PLANNING BOARD AGENDA

**May 12, 2025
REGULAR MEETING**

**Re: Completeness/Technical Review
Ennis Use Variance Application
1844 Fernwood Road
Block 14, Lot 21
H2M Project No. LKCP 2503**

**Re: Completeness/Technical Review
Papa Variance Application
1701 Newman Street
Block 7, Lot 1.01
H2M Project No. LKCP 2504**

FIRST FLOOR PLAN

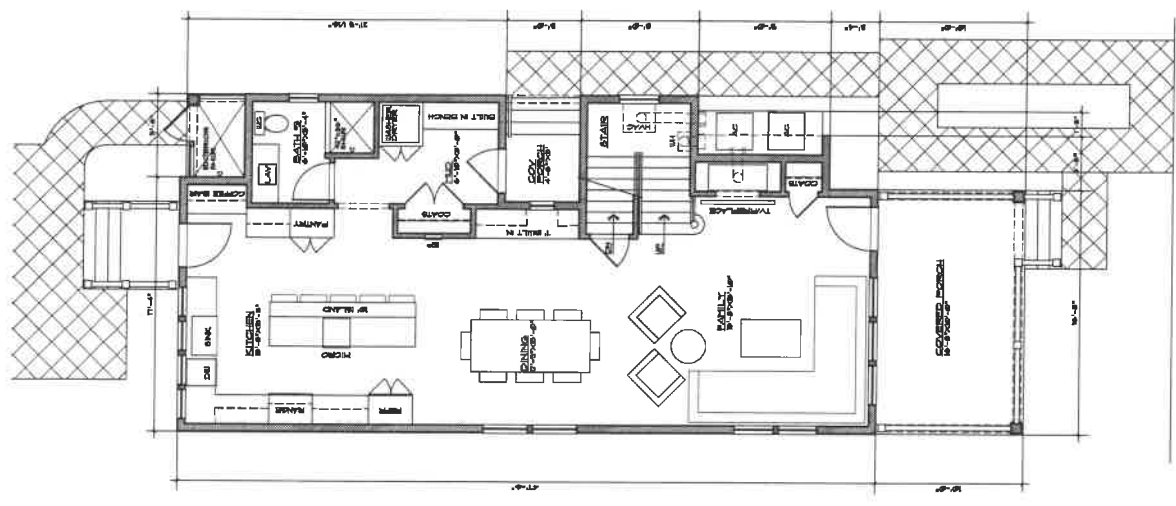
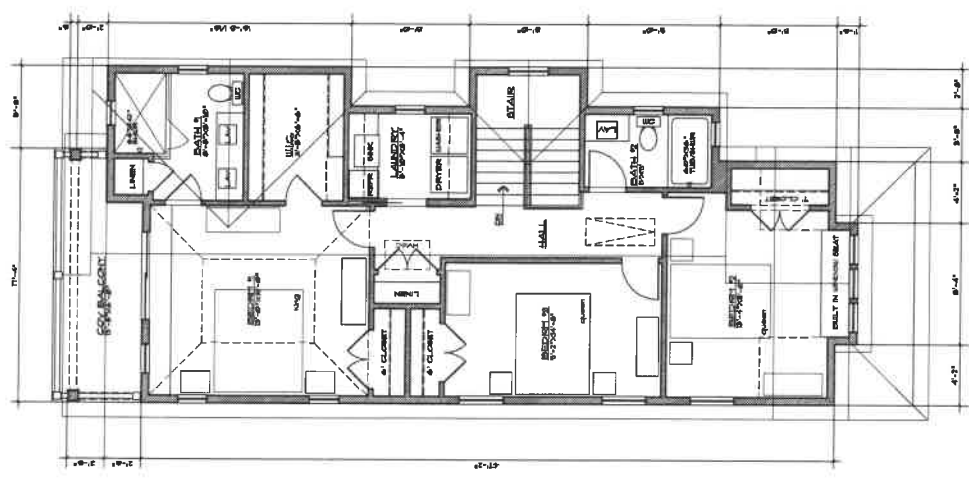
2. Code Section 17-10.7 outlines the off-street parking and driveway requirements for single-family dwellings. The proposed dwelling contains 3 bedrooms, which requires two parking spaces. The Applicant is proposing one parking space for the dwelling. A variance will be required for this proposed non-conformity.

3. The Application and the Architectural Plans both reference that the water table elevation is 1 foot below grade. However, there does not appear to be any reference as to where this information was gathered. The Board should elicit testimony regarding the Seasonal High Water Table elevation and documentation obtained to determine its actual elevation.

WEST (FRONT) ELEVATION

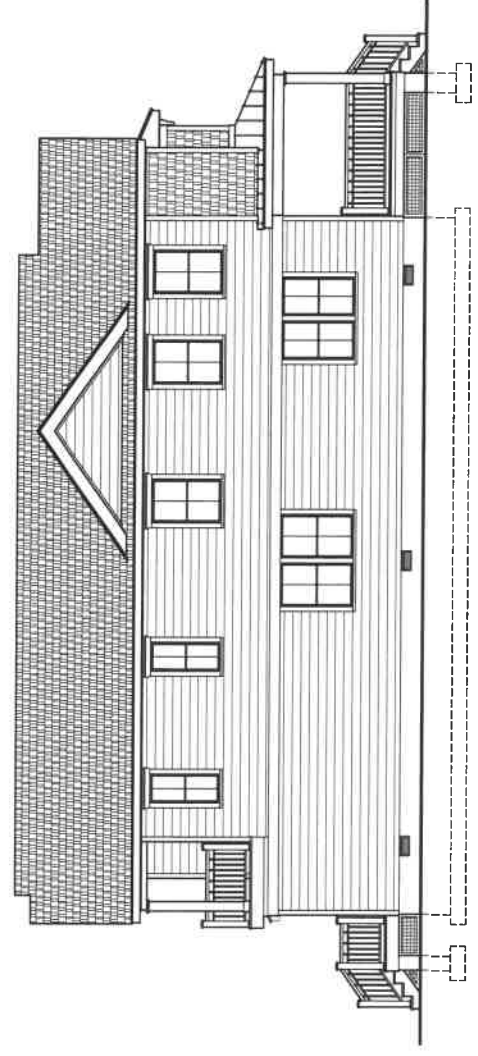
The existing non-conformities cited above are provided for the Board's information as none are exacerbated by the proposal. However, bulk variance relief will be required for the proposed front yard setback **bolded** above, and a Use criteria variance (d(6)) will be required for the proposed building height **bolded** above.

SUPERIOR BUILDERS	
1234 5th St. N. • Dept. •	
MINNAPOLIS, MINN.	
BUILDER/CUSTOMER	
FRONT ELEVATION - 1	
DATE	1/4-21-07
BY	10-00-00
SCALE	1/4" = 1'-0"
NO.	00000000

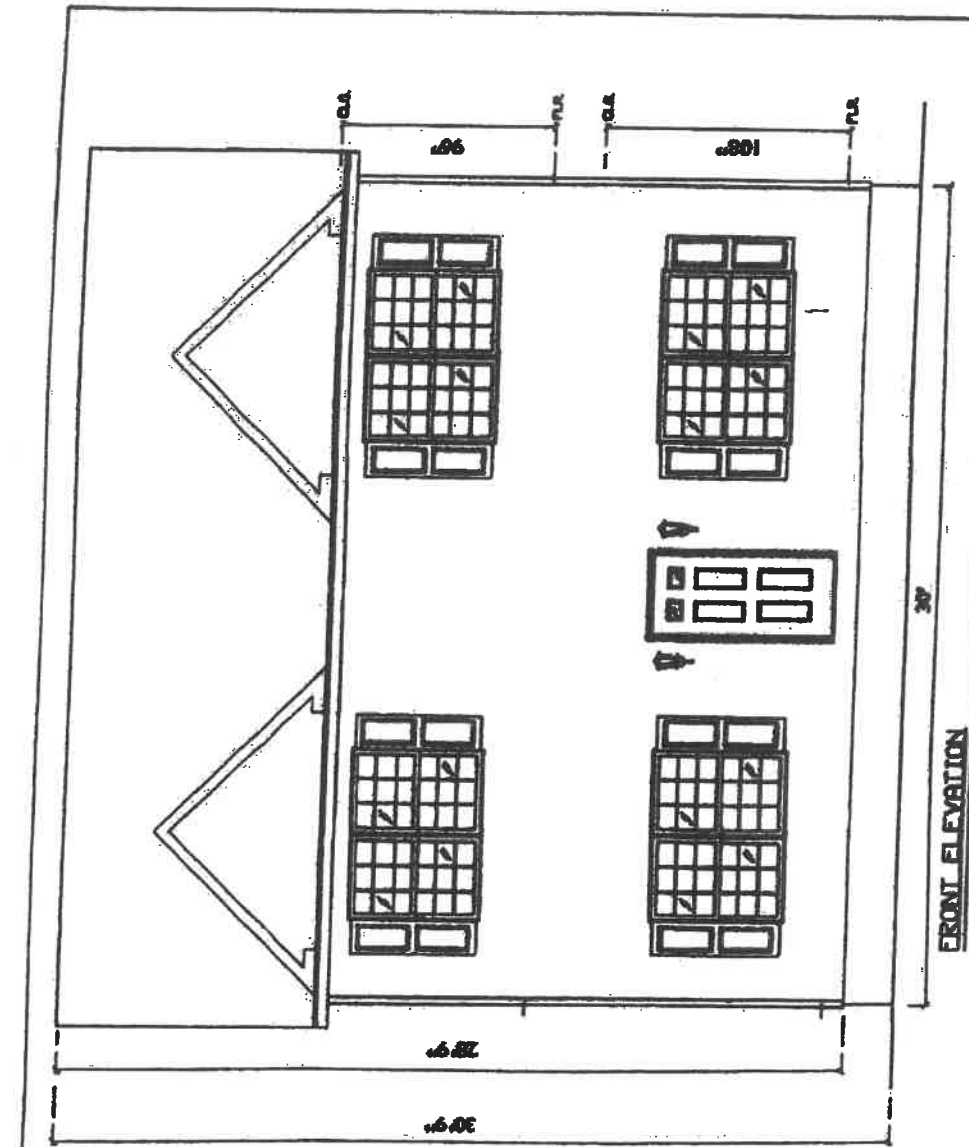
2. The Applicant did not provide architectural plans as part of the Planning Board application. The Applicant included a page in the denied Zoning Board application depicting the height of the proposed dwelling as 30.9 feet. The height of the proposed dwelling is not reflected on the site plan or on an elevation plan, and thus cannot be measured against the curb, as established in Code Section 17-7. The Board should elicit testimony to determine the proposed dwelling height and condition any approval on the submission and approval of architectural plans drawn to a recognized scale.

3. Code Section 17-7 specifies that all open front porches which project into the front yard setback must also be one-story. The covered porch is not depicted on the elevation document attached to the Zoning Application. The Board should elicit testimony to determine what is proposed above the covered porch and further require complete architectural plans depicting the entire proposal.

BOUNDARY TOPOGRAPHIC SURVEY
PREPARED FOR
BLOCK 7 - LOT 1.01
1701 NEWMAN STREET
CITY OF LAKESIDE, MINNESOTA COUNTY,
MINNESOTA

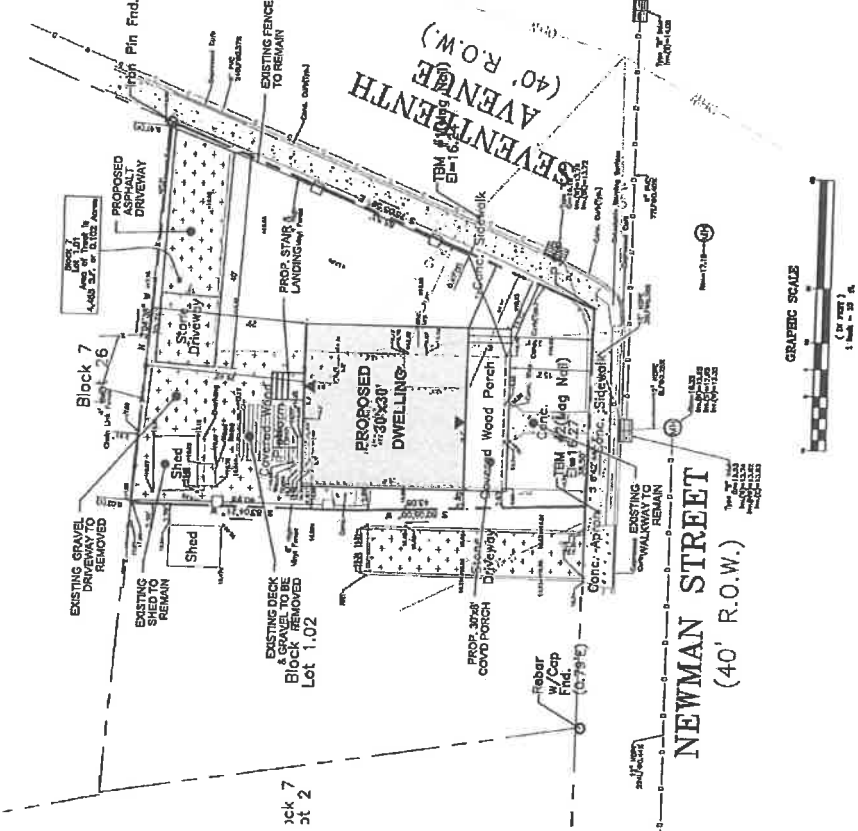
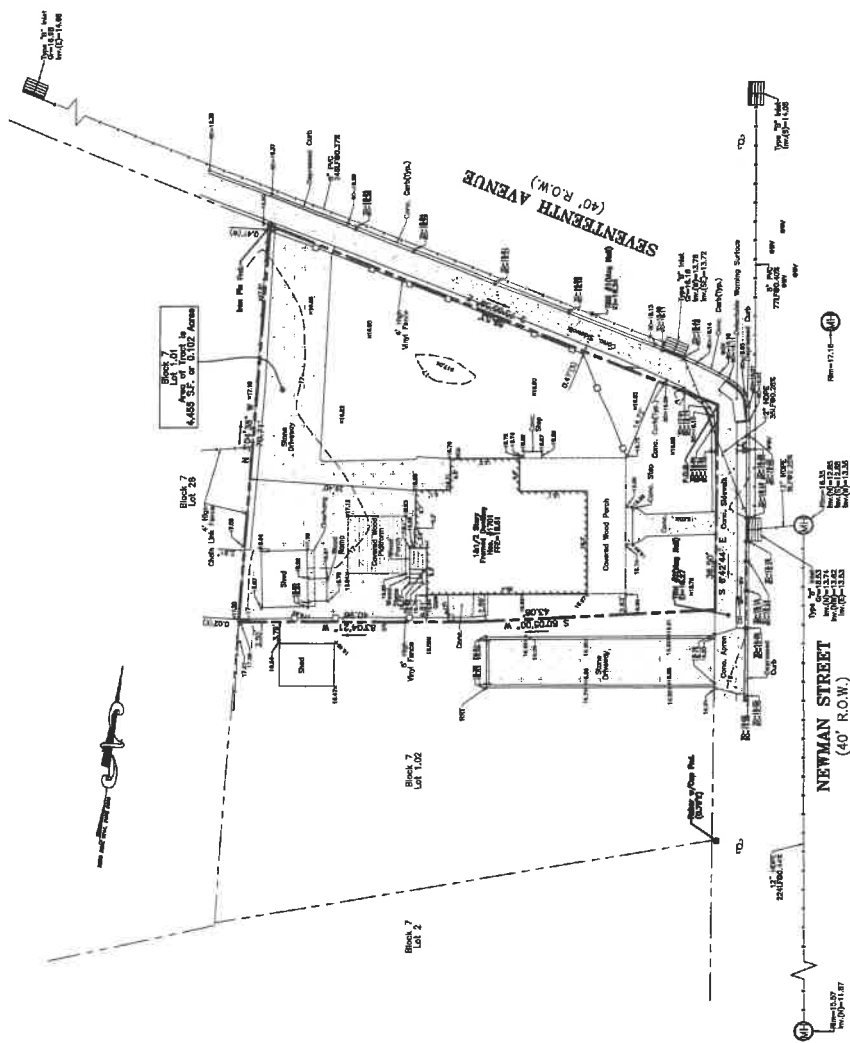
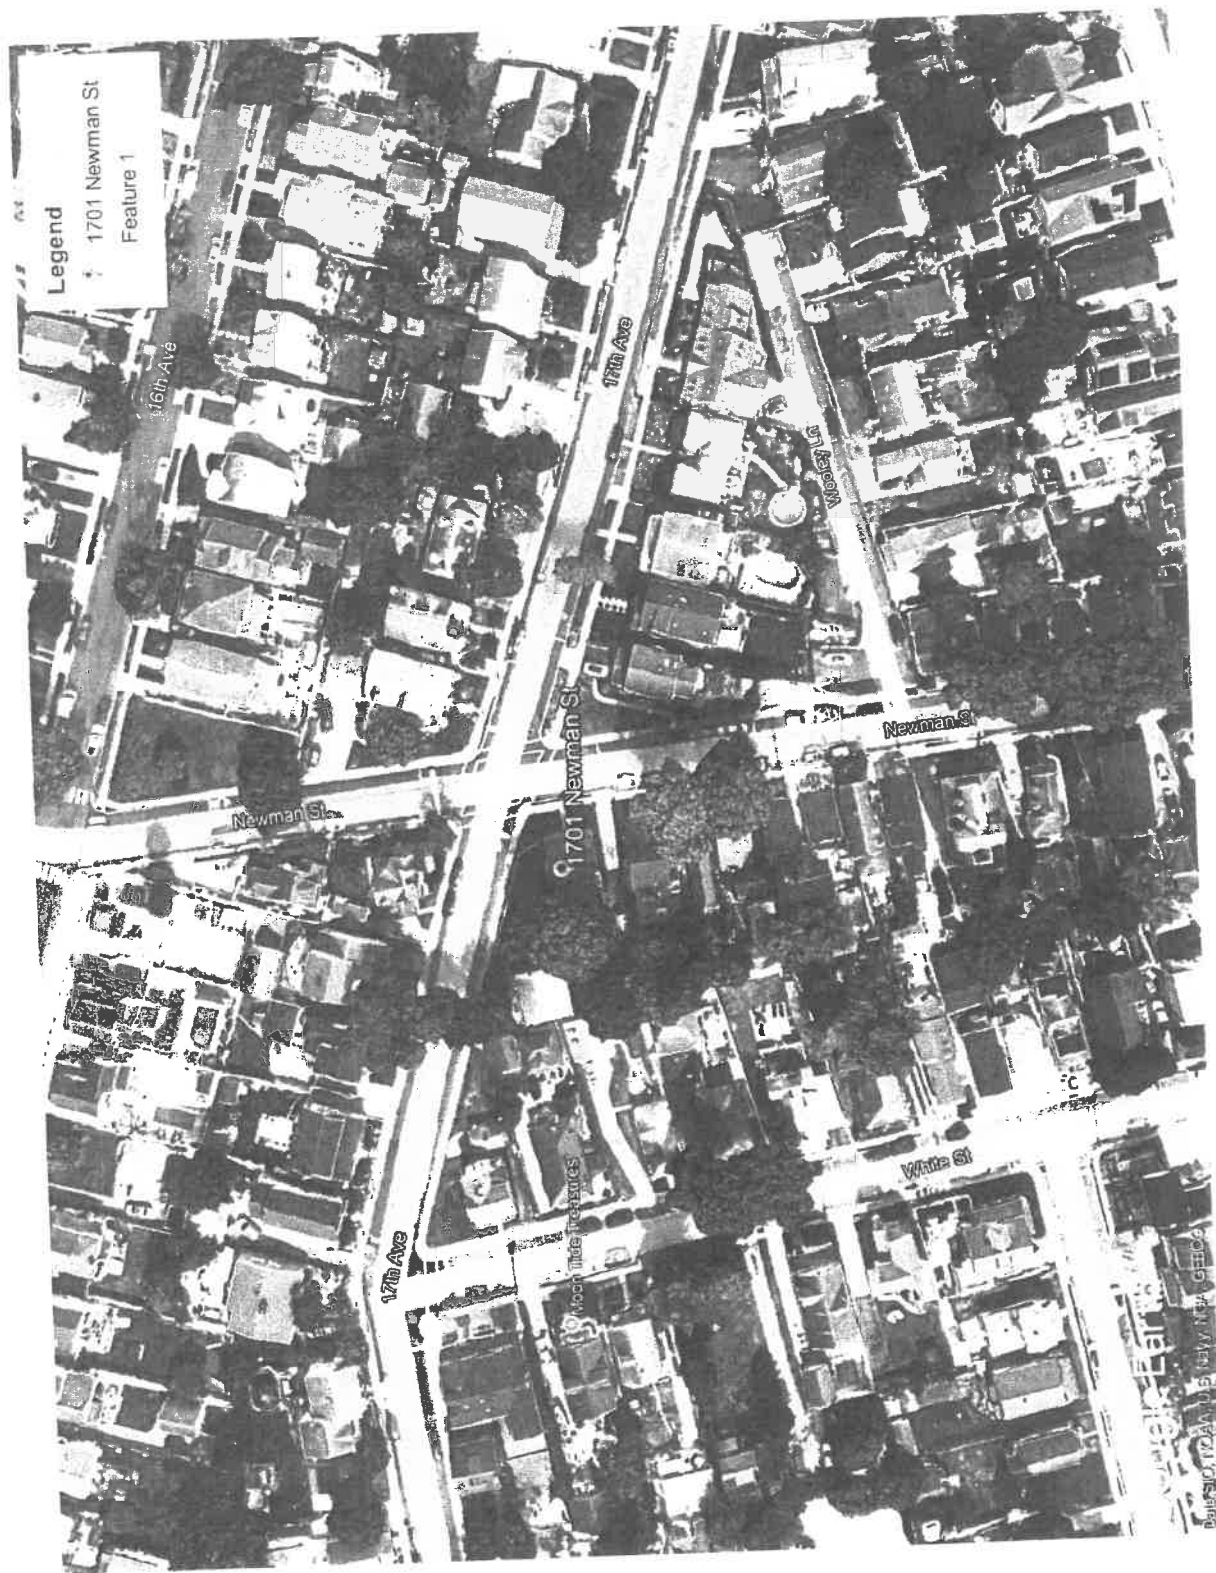
4. The Site Plan does not depict the proposed grading and drainage for the property. The grading depicted on the Site Plan matches that found on the Boundary and Topographic Survey. The Board should elicit testimony regarding the proposed grading and drainage on the site to prevent impacting neighboring properties, and further condition any approval on submission and approval of a Grading and Drainage Plan as required by ordinance.

5. A site visit revealed sections of the sidewalk adjacent to the Applicant's property along Newman St are in disrepair. The Board should condition any approval on the replacement of aged sidewalk flags.

6. The site visit revealed that there is an existing fence at the front of the property that includes a gate across the driveway. Given the tight confines of 17th Avenue adjacent to the site and the vertical and horizontal configuration of 17th Avenue there, I am concerned with the continued safety of the public where the users of this property must stop in the traveled way to open the gate to enter the site. The Board should elicit testimony regarding the necessity of this condition and consider conditioning any approval on the elimination of this feature.
